TO: Urban Design Commission
FROM: David C. Dryer, City Traffic Engineer & Parking Manager
SUBJECT: 333 West Washington Avenue project

Re: Letter of Intent, Capitol West (Phase II), PUD – SIP

Project: Capitol West – Phase II, Hyatt Place Hotel
333. W. Washington Ave.

**Re: Urban Design Commission Submittal – Initial/Final approval requested
Capitol West (Phase II), PUD – SIP
UDC GDP comments addressed**

PROJECT NO.
06077
SHEET TITLE
ELEVATIONS

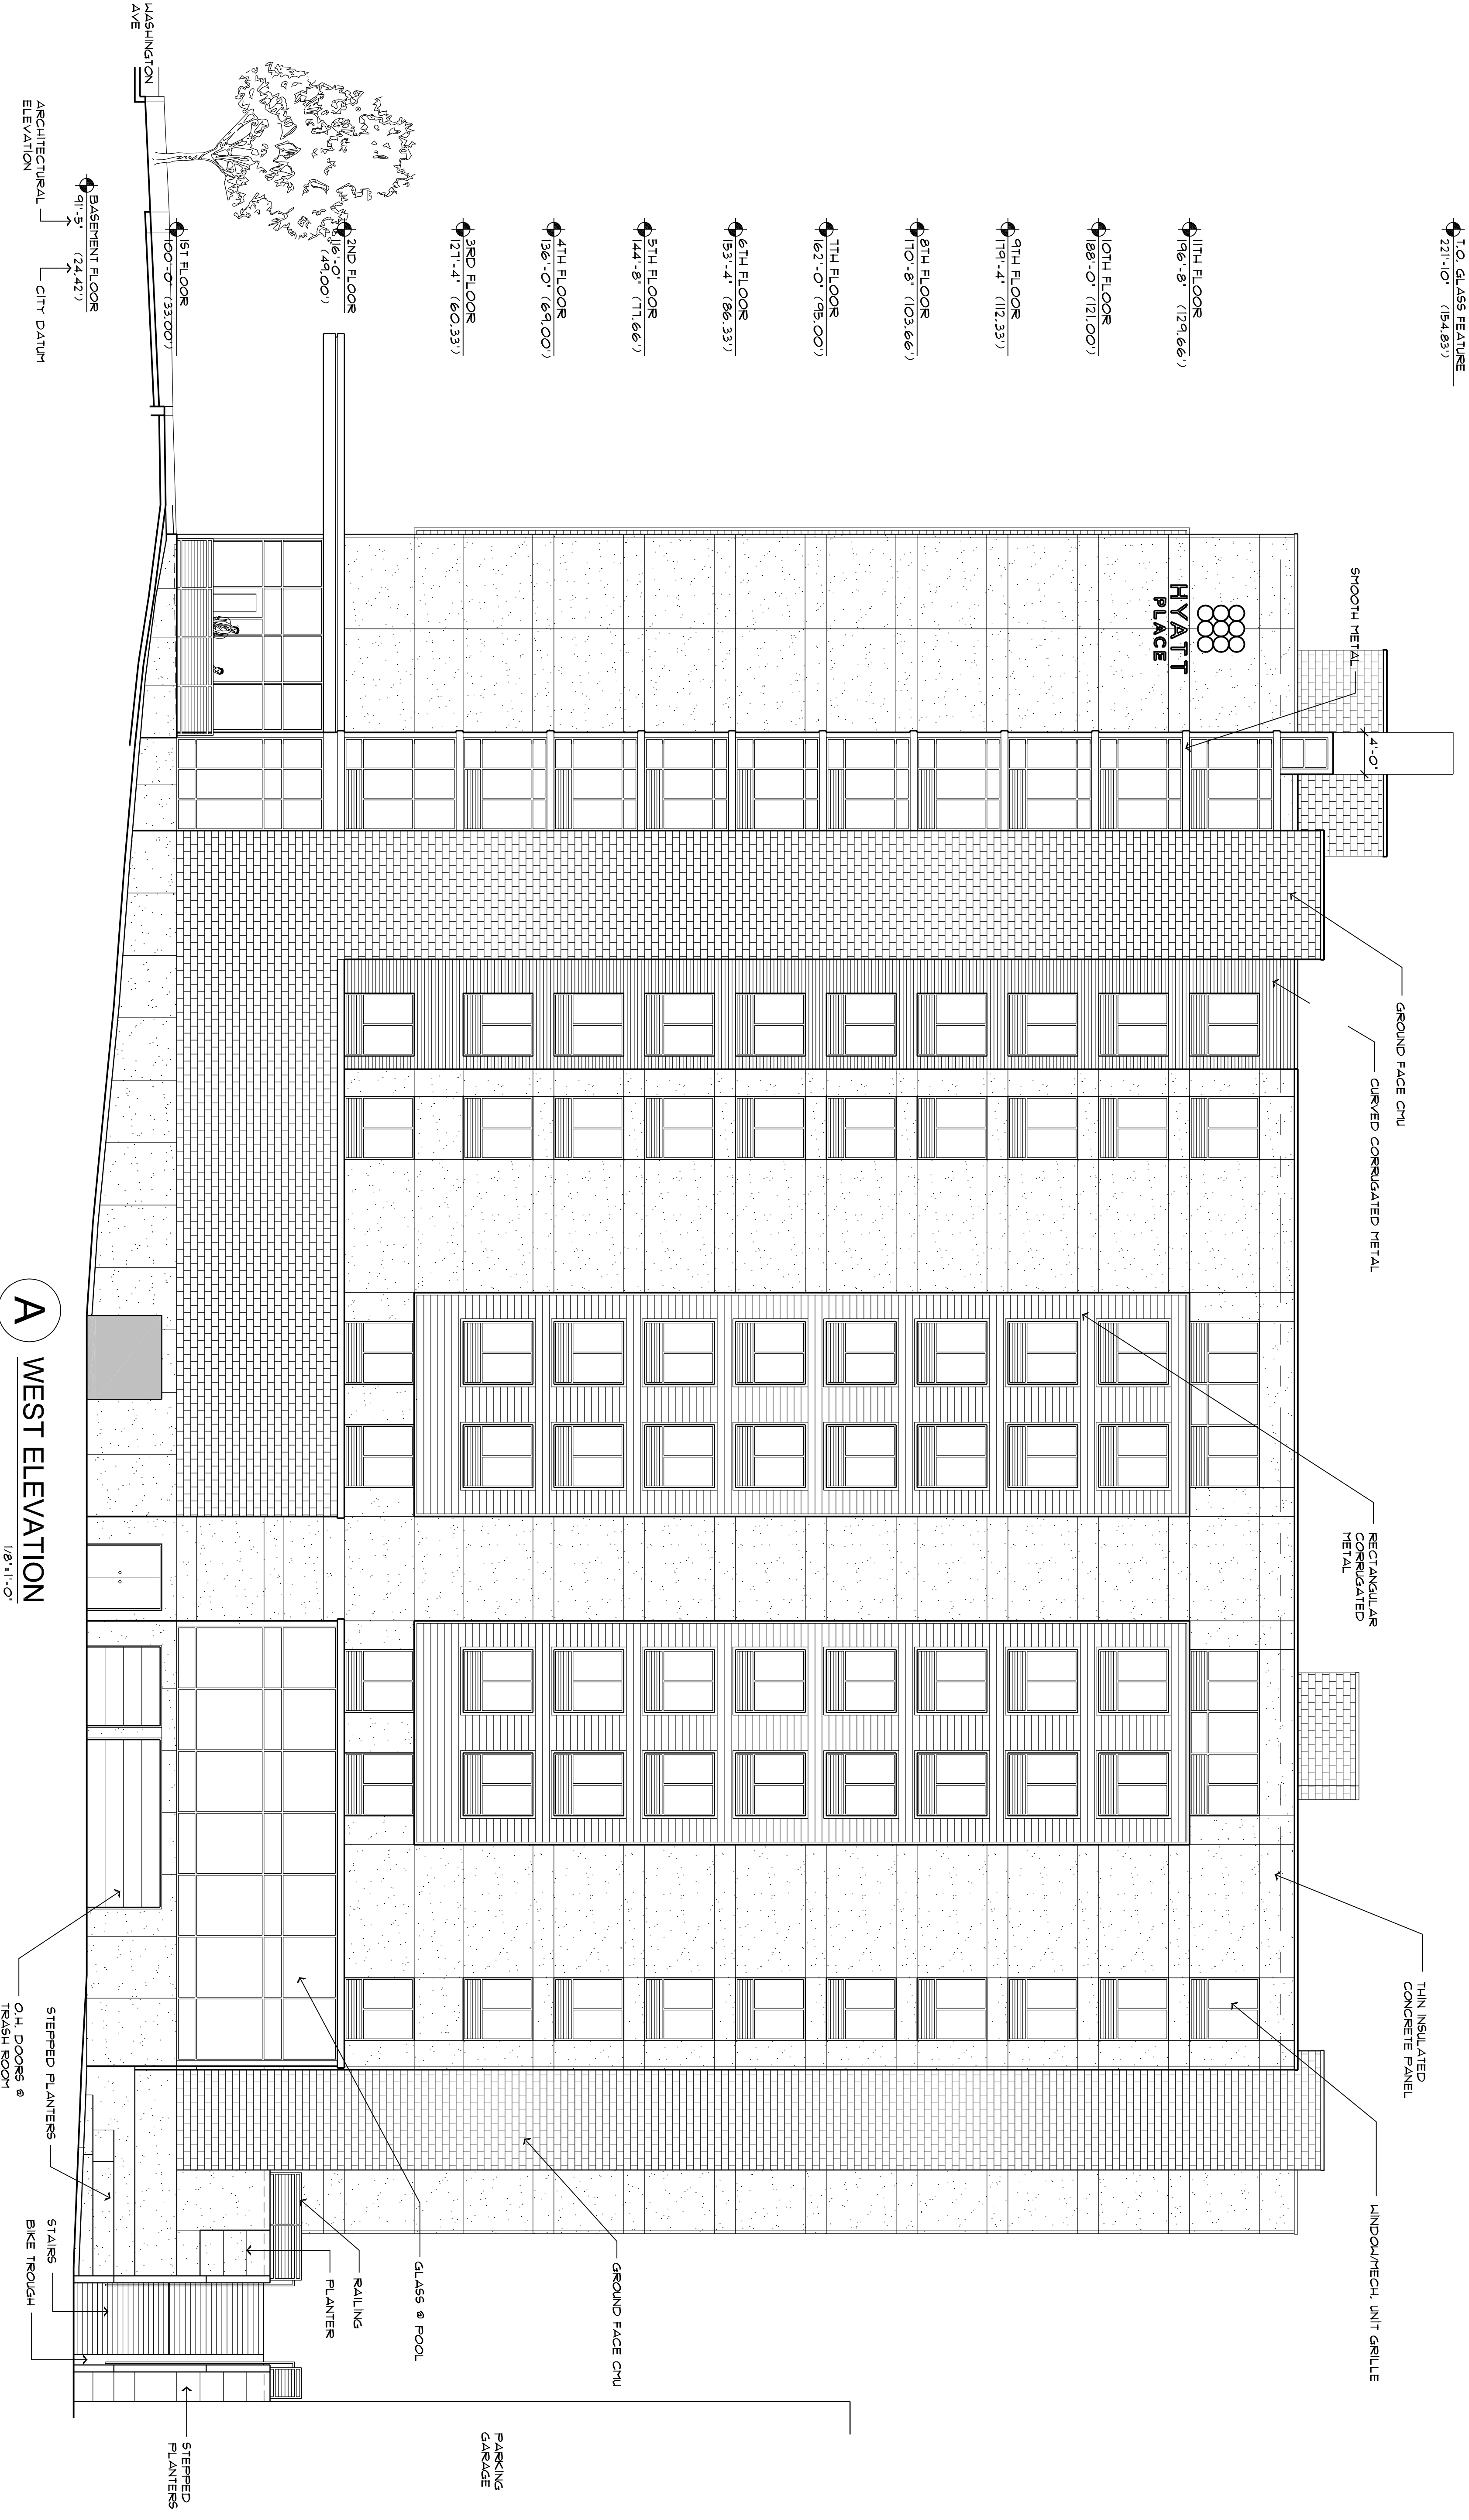
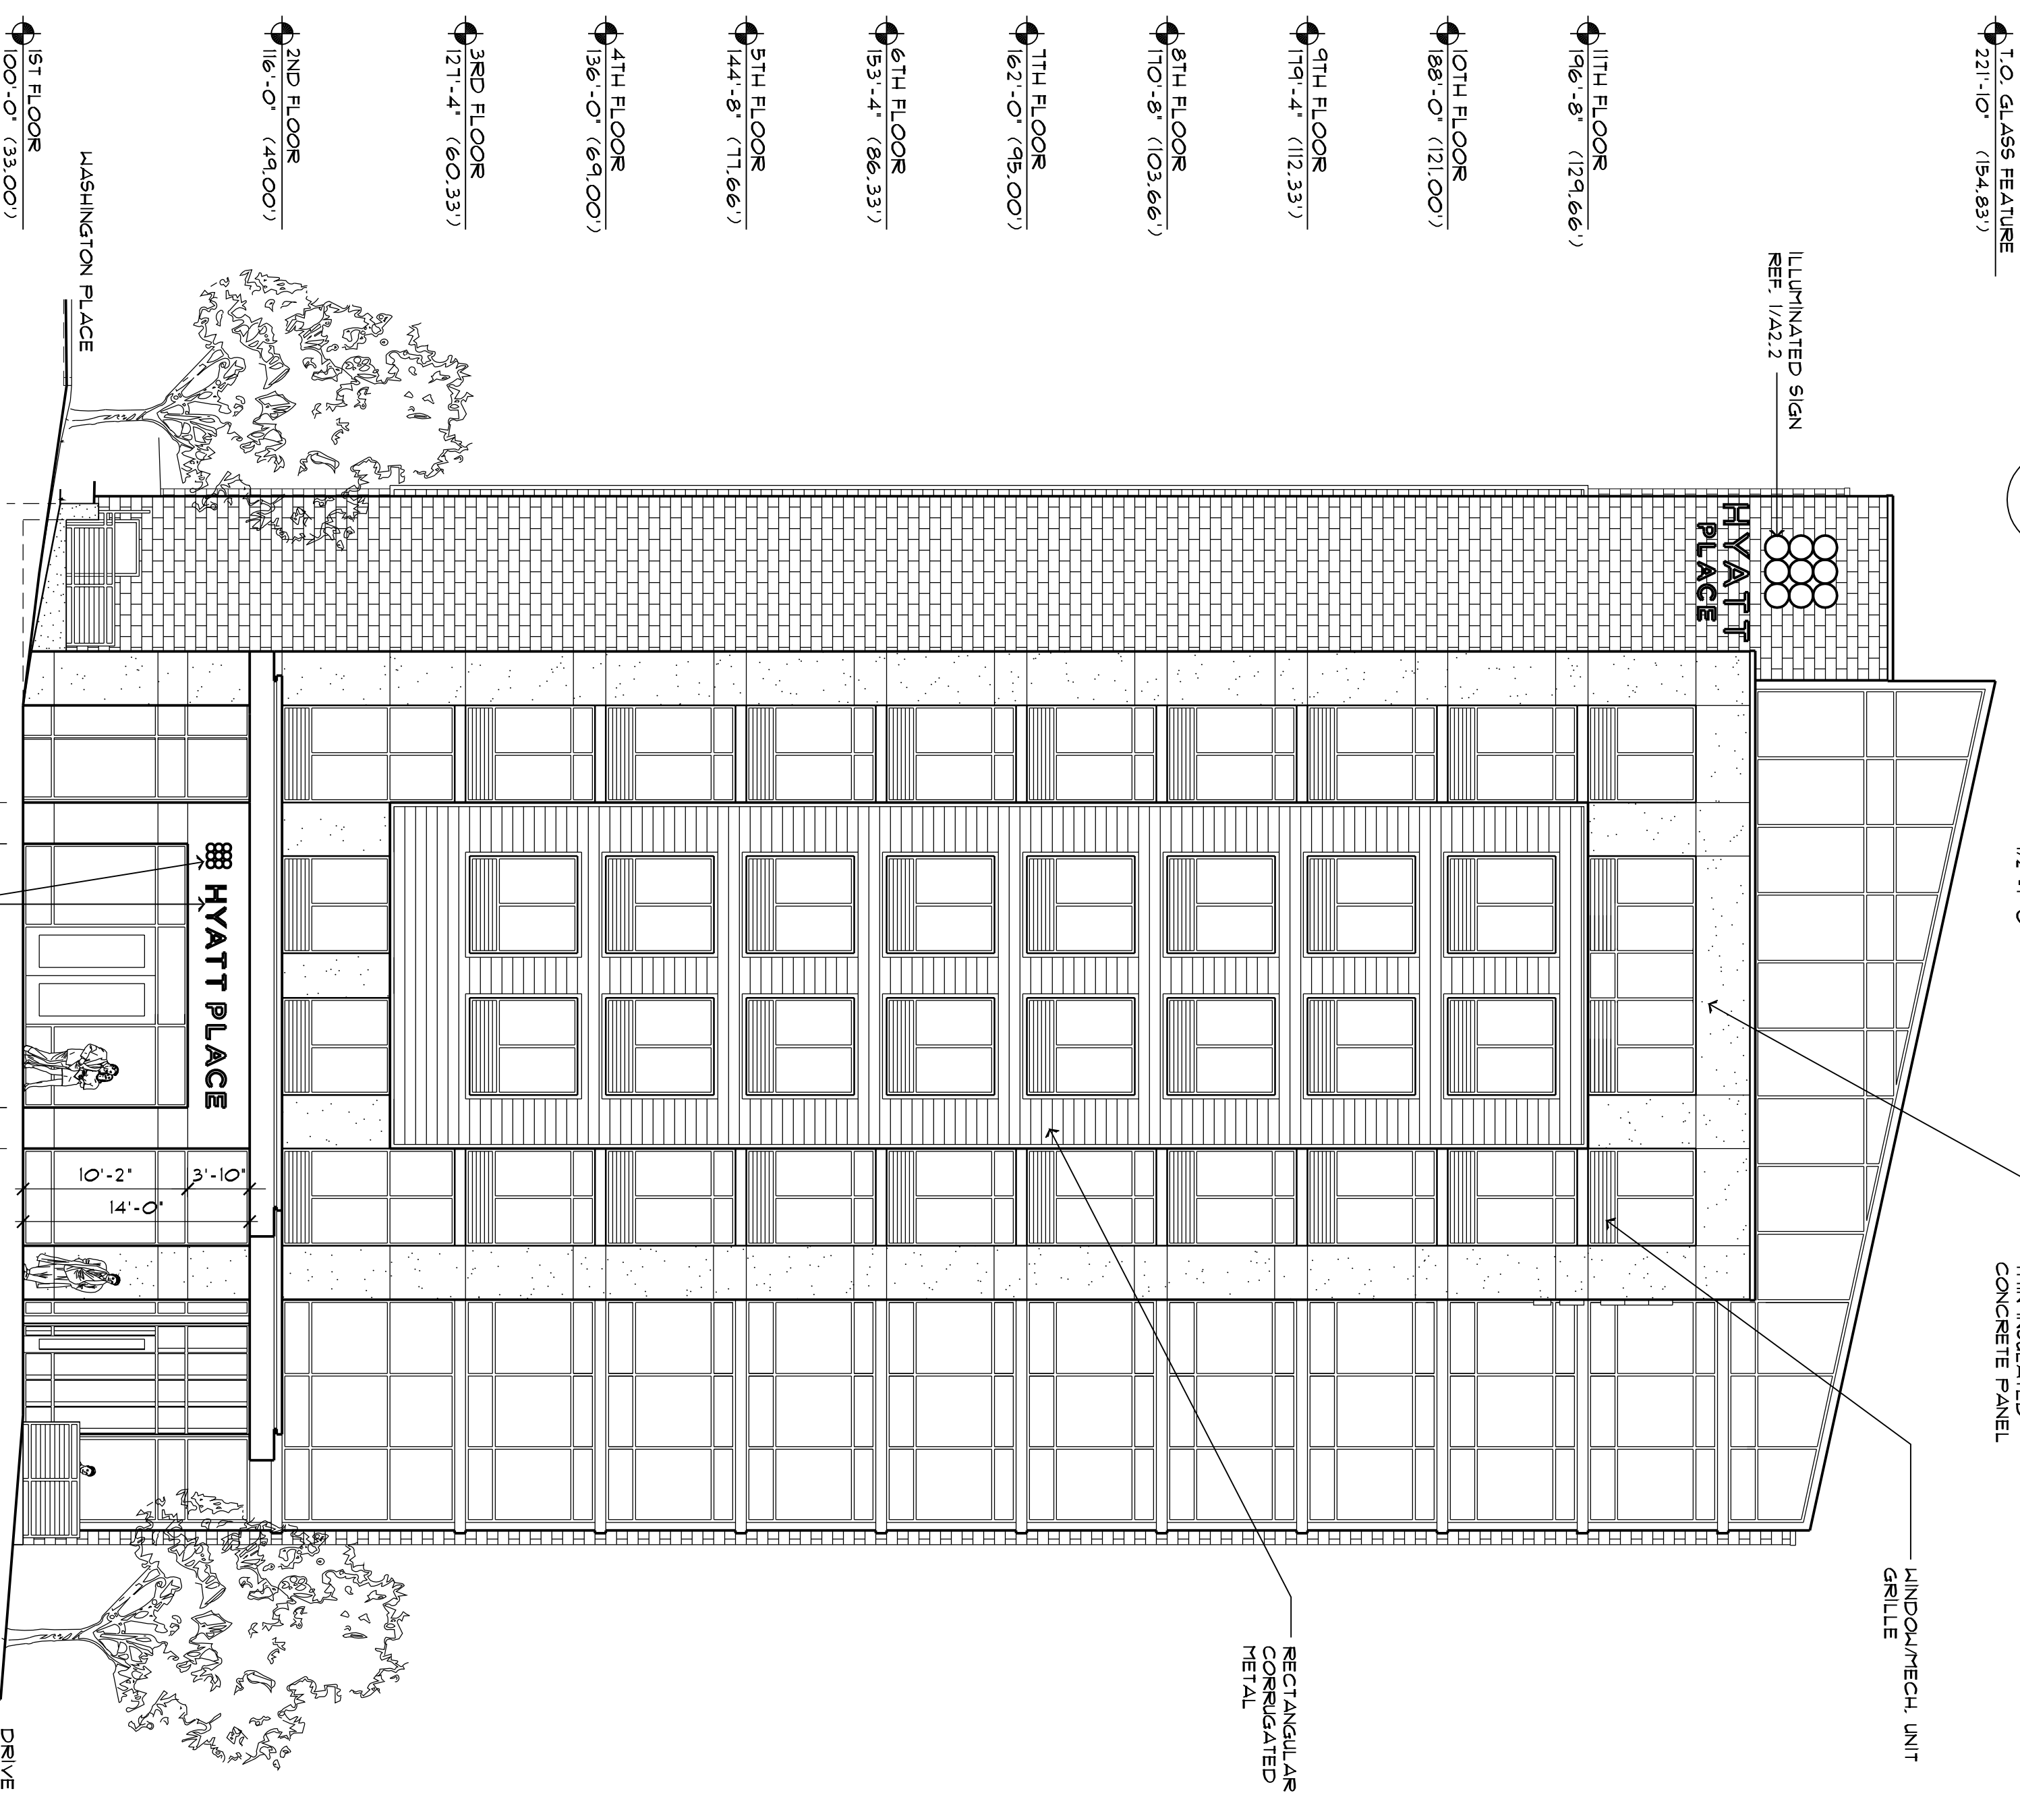
- C** Copper projecting bay too low on the Washington Place
 - R** Copper panels on east elevation have been raised. (Note: copper panels on all facades have been raised.)

- C Neighborhood viewscape around the building.
 - R The east and south façades have been modified to provide more visual interest from the Mews (east facade) as well as the south by wrapping the corner with corrugated panels.
- C Green Roof.
 - R Not currently planned.
